Intel[®] 82575EB Gigabit Ethernet Controller Specification Update

LAN Access Division (LAD)

Revision: 2.67
December 2011

Figure 1. Device Identifying Marks (Similar)

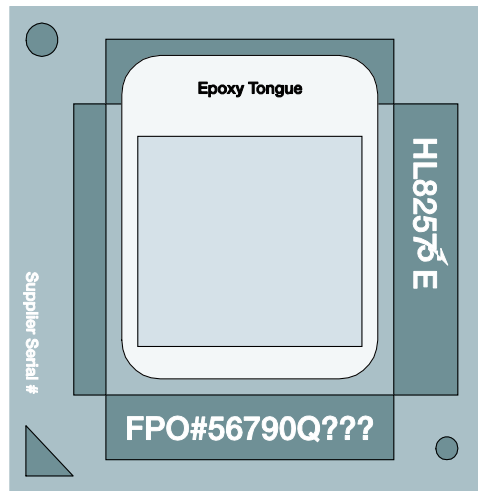
Lead-free parts have "JL" as the prefix for the product code (vs. "HL") and that the "Q" designator refers to the Q Specification number in the table.

Devices can also have a "GB" marking; these devices are used only on Intel network interface adapters. The "GB" is functionally equivalent to the "EB" device.

There is an internal designator visible as a dash on the die side of some packages. The location may differ. The mark (looks like a dash, approximately 300X1000 μm in size) does not impact function.
